Business Unit	Product line	Product key	Modification-No.	Initials of author (User-Kennung)	Date of Issue
DC	COMBICON	AAA	AAA170098	PBST29	17.10.2017

**Brief description of the modification**

Inserting of a screw brake

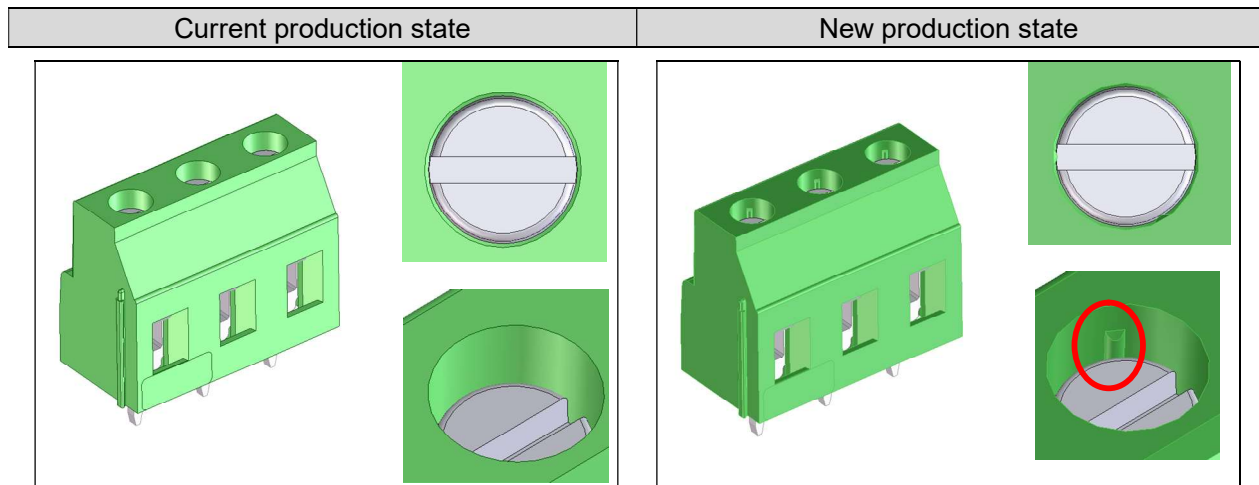
Due to our continuous improvement process the above mentioned articles will be delivered with an additional screw brake. Three plastic fins are inserted in the screw shaft to prevent the closing of the clamping space during transportation. Dimensions and technical data remain the same. During the conversion period both versions will be delivered depending on the inventory.
